Road Safety Audit Report

Dell Range Boulevard from Powderhouse Road to College Drive & Prairie Avenue from Powderhouse Road to Dell Range Boulevard

Cheyenne Metropolitan Planning Organization
2101 O'Neil Avenue, Room 205,
Cheyenne, WY 82001

June 2013

Exhibit 7 Example Ring-and-Barrier Diagram Showing Protected Lead-Lag Left Turns (source: FHWA Signal Timing Guide)

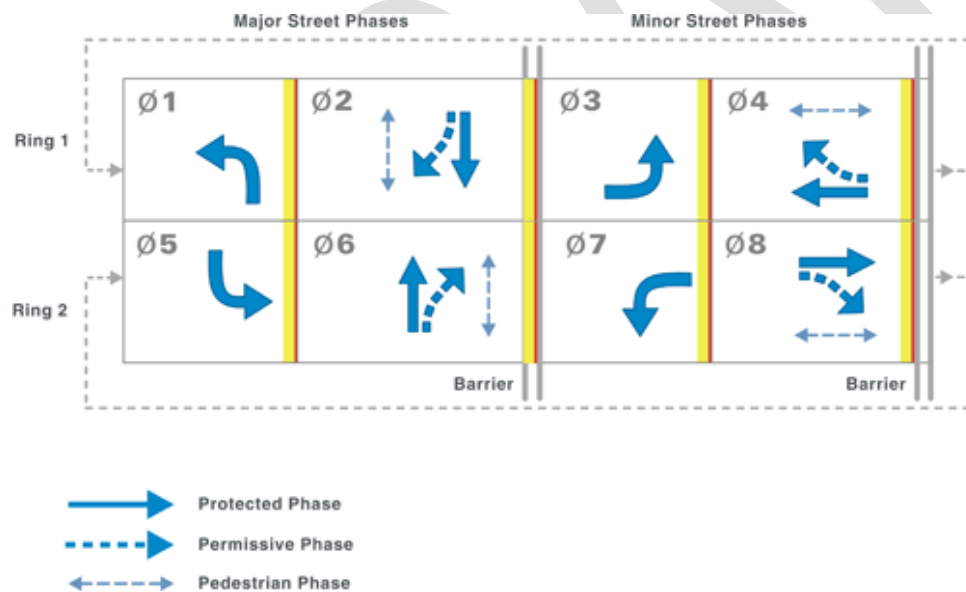
Existing signal timing provides inconsistent use of left-turn phase sequences along the corridor. At some signals the east-west protected left-turn phase occurs before the permitted phase, but at other signals the protected phase “lags” behind the permitted phase. There are three potential issues associated with left-turn signal phasing: 1) inconsistency violates driver expectations and can increase driver error, 2) providing a leading protected left-turn phase reduces the demand during the permitted phase and reduces the potential for driver error during the permitted phase, and 3) permitted left-turns may increase potential conflicts between pedestrians in the crosswalk. These issues may have contributed to the 203 angle crashes reported at signals within the study corridor.

Allowing variations in the phasing sequence throughout a corridor is a common strategy for improving signal coordination and reducing delay, but inconsistent left-turn phasing may increase driver error. Drivers accustomed to one left-turn phasing sequence may assume other signals on the corridor have the same phase sequence.

When the protected left-turn phase “leads” and is followed by the permitted left-turn (See Exhibit 7), more vehicles proceed through the intersection during the protected phase and additional vehicles can proceed on the permitted phase if there is a gap in oncoming traffic. The protected left-turn phase follows (or “lags”) the permitted phase at many of the signals on Dell Range Boulevard, which increases the number of vehicles that are exposed to making an error when making the left turn against the flow of oncoming traffic.

A recent study indicates that relatively few (4-9 percent) of left-turn drivers turning during a permitted phase look for pedestrians in the conflicting crosswalk. Most drivers in this situation are only watching for

a gap in oncoming traffic.¹ This trend provides additional incentive to provide protected left-turn phasing for a majority of left-turn vehicles through a leading protected left-turn phase.

Consider providing leading protected left-turn phasing to promote consistency along the corridor, minimize potential for driver error, and minimize potential conflicts with pedestrians.

Exhibit 13 Pedestrian Push Button in NW Corner of Dell Range/Rue Terre Intersection

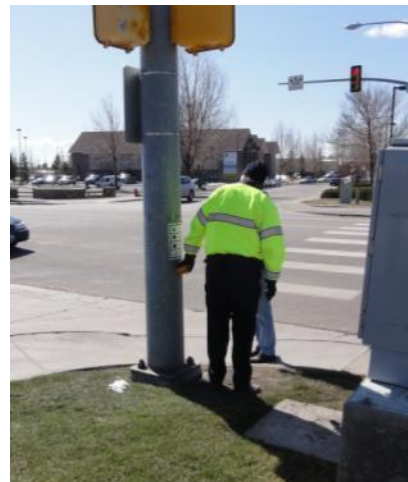
Multiple design elements do not meet ADA requirements. Observed design elements that do not meet ADA requirements include:

- Clear width of pedestrian ramps and sidewalks less than 4 feet in many locations. Width limited by signal poles or other obstructions located in pedestrian path
- Slope of pedestrian ramps exceed maximum of 8.3 percent
- Cross-slope of sidewalk exceeds 2 percent at driveways
- Lack of truncated domes or tactile surface on pedestrian ramps
- Pedestrian ramps not aligned with crosswalk
- Inaccessible pedestrian push button locations (i.e. back of signal pole, or hard surface not provided up to base of button)

As part of other improvements to the overall corridor, pedestrian facilities can be updated to meet ADA requirements.
